# Access Compliance Report

## Public Rights-of-Way

Intersection ID: 53270	Main Street: MONROE_RD	Cross Street: MERIDIAN_CENTER_DR	Location: NE
ADA ID: 54E282298A8A	Ramp Type: Directional1	Initial Pass/Fail: Fail	Overall Compliance: No
		Severity Score: 1.25

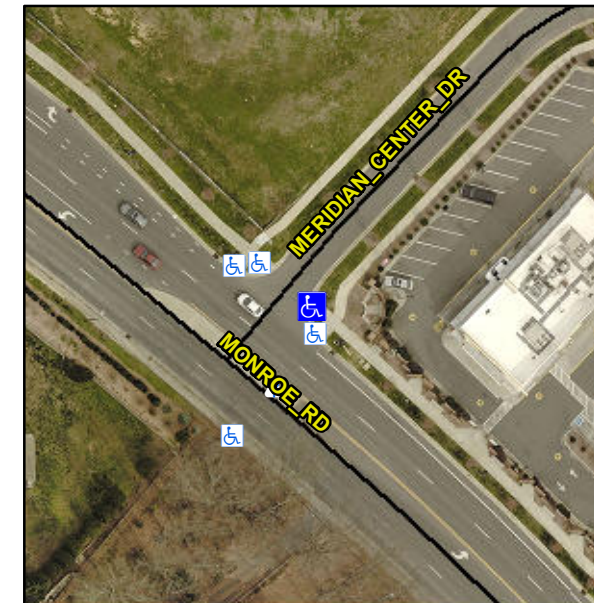
**R304.5.3**

Compliance	Description	Data	Compliance	Description	Data
N/A	Ramp Length (in)	95.0	N/A	Grade Break?	N/A
Yes	Ramp Width (in)	72.0	N/A	Grade Break Slope (%)	0.0
Yes	Ramp Slope (%)	6.3	N/A	Grade Break XSlope (%)	0.0
No	Ramp XSlope (%)	2.3			
N/A	Flare Type LT	N/A	N/A	Flare Type RT	N/A
N/A	Flare Slope LT (%)	N/A	N/A	Flare Slope RT (%)	0.0
N/A	Flare Traversable LT?	N/A	N/A	Flare Traversable RT?	N/A
N/A	Landing Length (in)	0.0	N/A	DWS Provided?	N/A
N/A	Landing Width (in)	0.0	N/A	DWS Contrast?	N/A
N/A	Landing Slope (%)	0.0	N/A	DWS Length (in)	N/A
N/A	Landing X Slope (%)	0.0	N/A	DWS Full Width?	N/A
N/A	Landing Curb? (Y/N)	N/A	N/A	DWS Offset LT (in)	N/A
N/A	Shared Landing?	N/A	N/A	DWS Offset RT (in)	N/A
N/A	Gutter Ponding?	0.0	N/A	Gutter Slope (%)	N/A
N/A	Gutter Lip Ht (in)	0.0	N/A	Gutter X Slope (%)	N/A
N/A	Painted X Walk1?	No		Road Slope (%)	1.0
	X Walk 1 Direction	To NW		Road X Slope (%)	1.1
	X Walk 1 Width (in)	N/A		Clear Space?	N/A

**Remove & Replace Entire Ramp.**
